Responses to EPA (D. Kappleman) Comments on Preliminary Volume Estimates for EPA's Partial Excavation Options West Lake Landfill OU-1

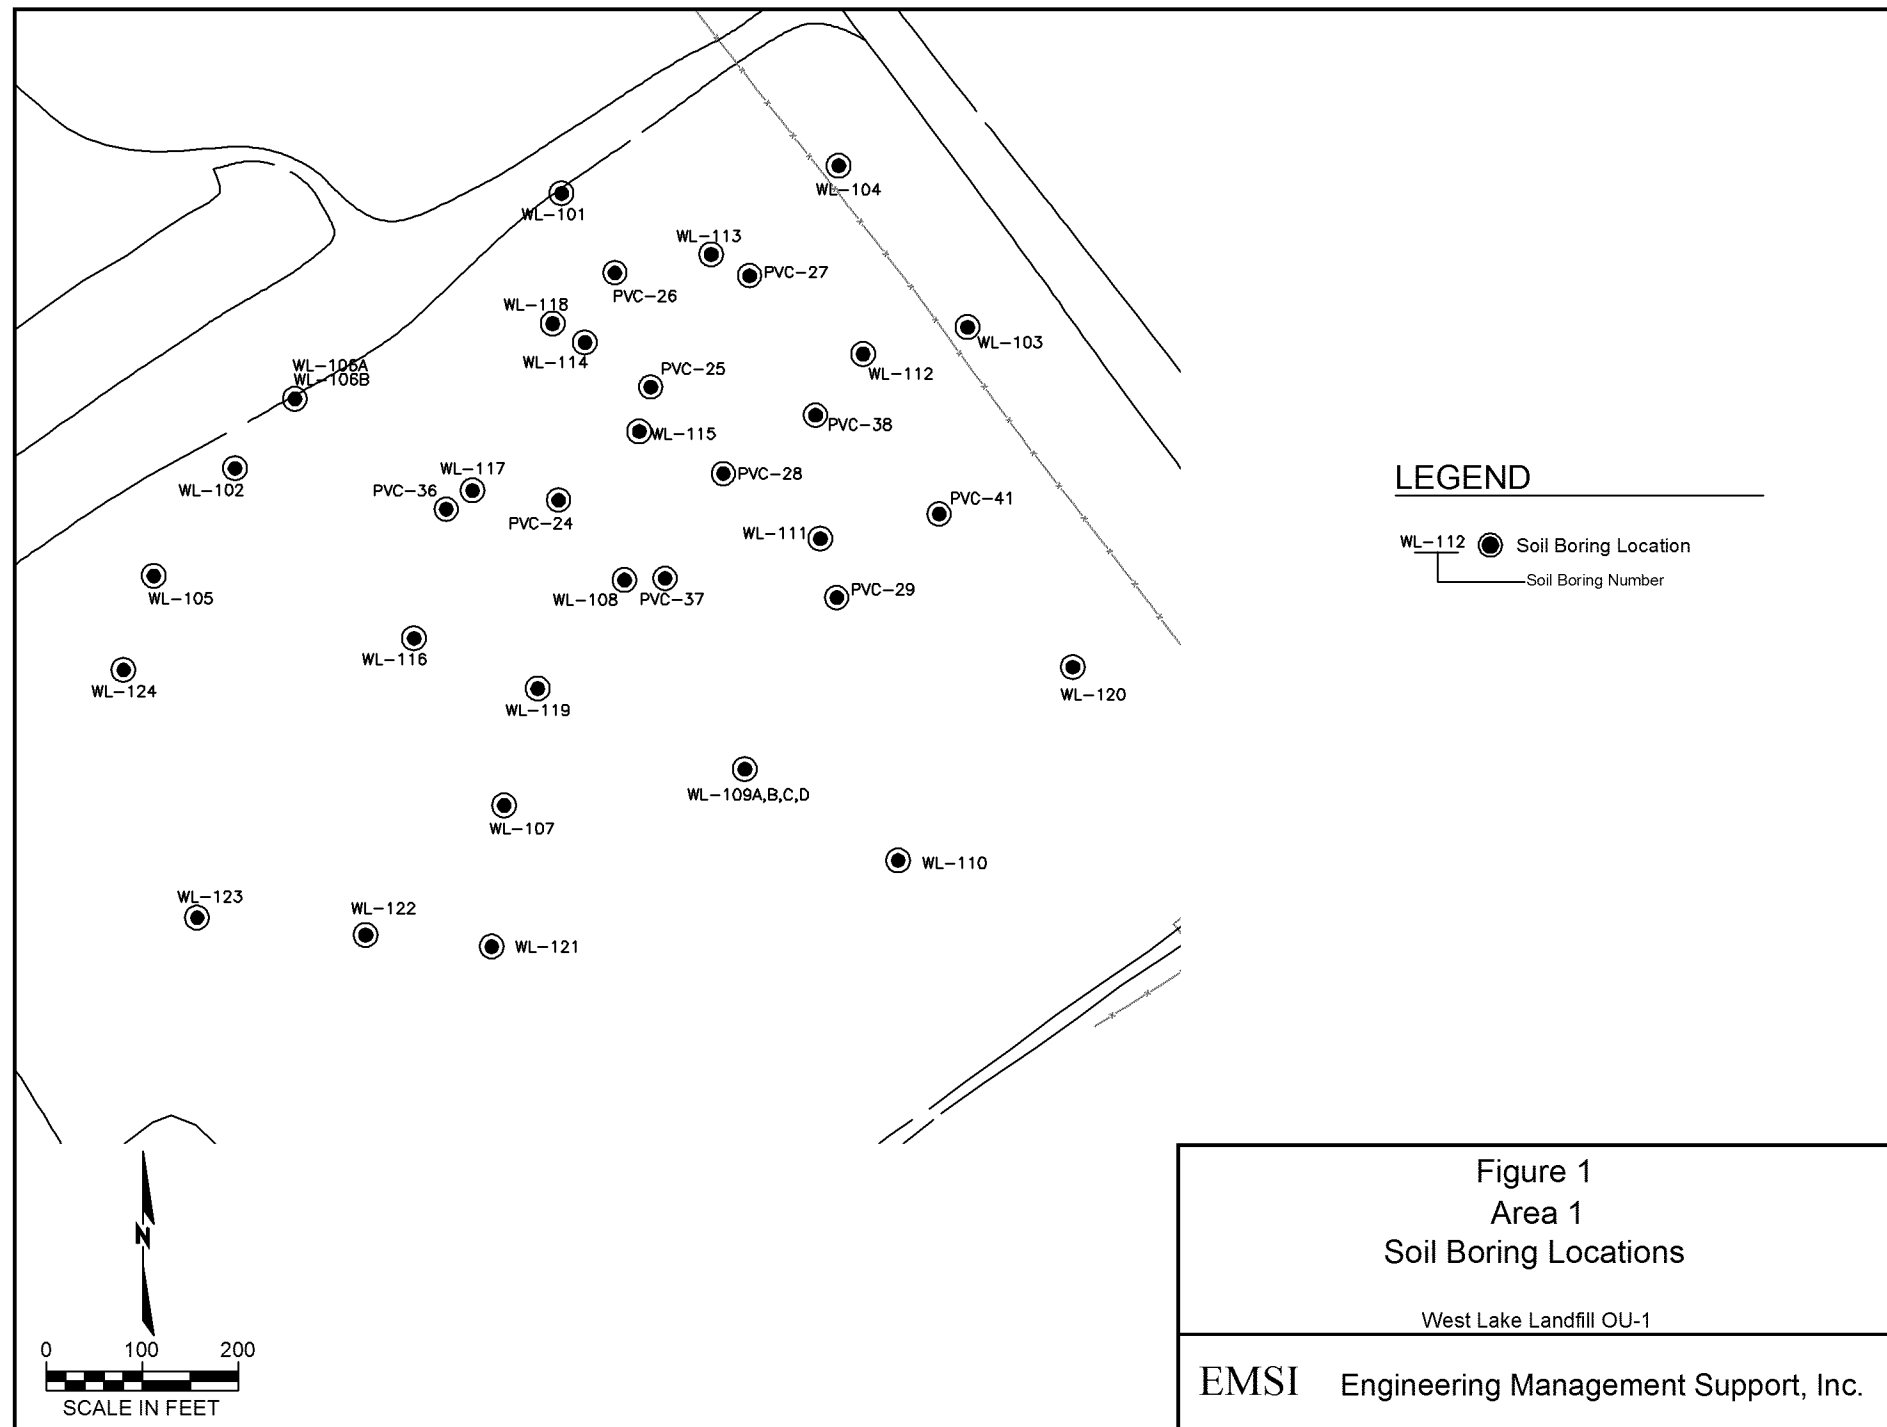
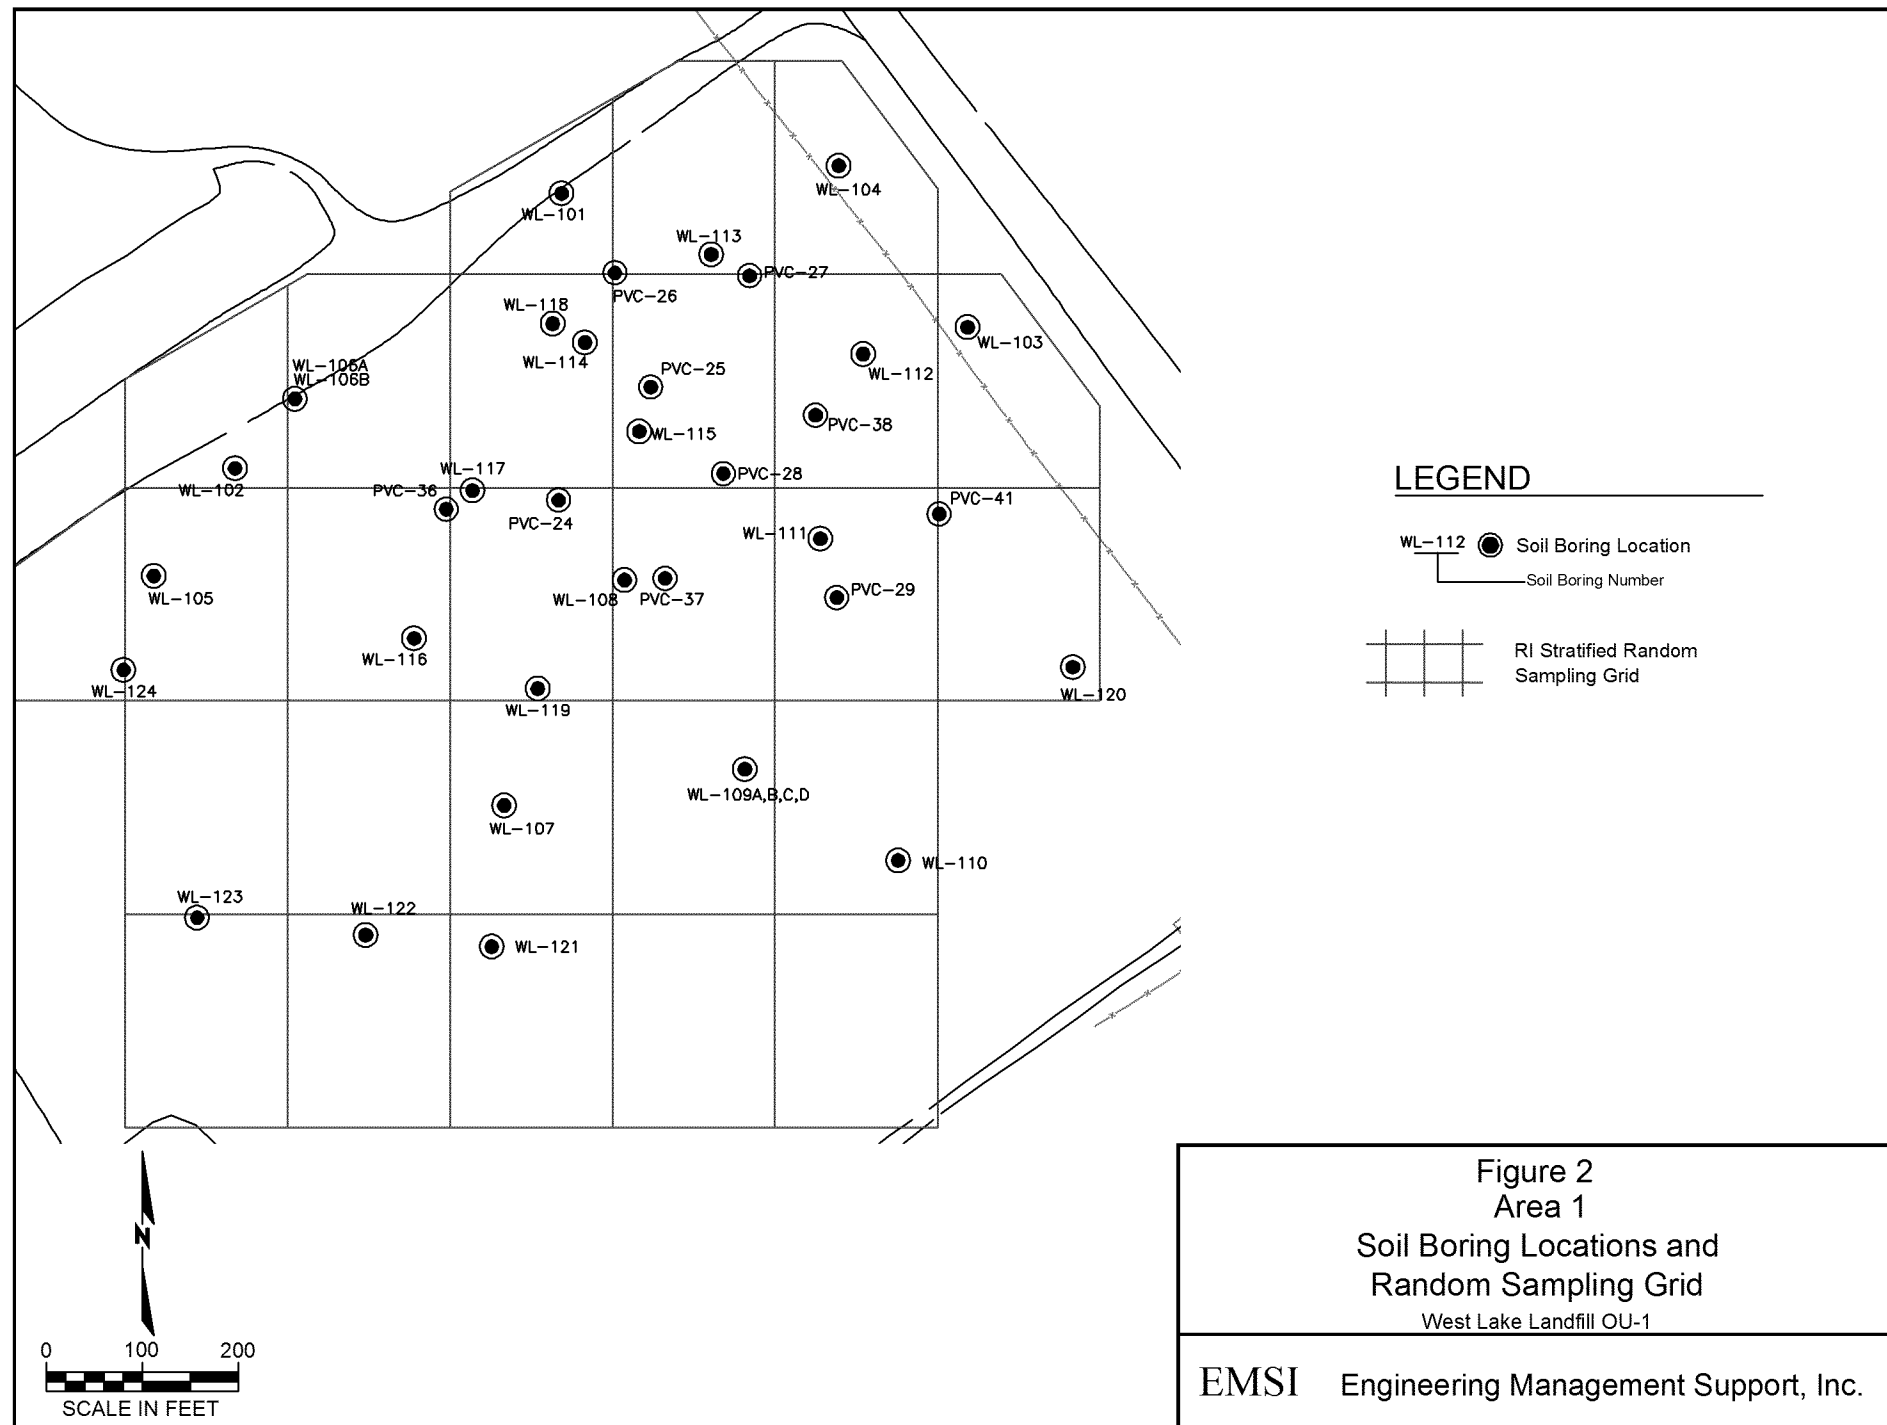
Comment: Drawings should include the Figure 1-3 Soil boring locations from the West Lake Landfill OU-1 Remedial Investigation Report just before Appendix B-2.

Comment: The assumption being made by the scenarios "assume" that all areas between contaminated sampling points are also contaminated within the gray shaded area are above the "Scenario Concentrations". Additional measurements and sampling will need to be performed to confirm the actual footprint.

Figures showing the locations of the soil borings were included in both the SFS report and the RI report; however, such figures can also be included as part of the preliminary volume estimates for the partial excavation options if EPA determines that a revised preliminary volume estimate report is necessary. We have included

such figures with these responses to comments in conjunction with our responses to some of the other comments provided by EPA (please see the attached Figures 1 and 7).

We have assembled a series of figures (many of which were provided in previous reports for the site or that represent combinations of information provided on figures included in previous site documents) that overlay the locations of the RI and NRC borings with the results of the RI overland gamma survey (Figures 1 – 12). These overlays clearly indicate that although in some areas the borings may be spaced a few hundred feet apart, the likely presence of RIM in between these borings is supported by the results of the overland gamma survey and the understanding of the method of LBSR disposal. We have also attached Figure 12 from the SFS report which presents overlays of the results of the NRC, RI and SFS evaluations of the extent of RIM occurrences at the site. This figure demonstrates how all three of these evaluations independently arrived at extremely similar estimates of the extent of RIM in Areas 1 and 2.
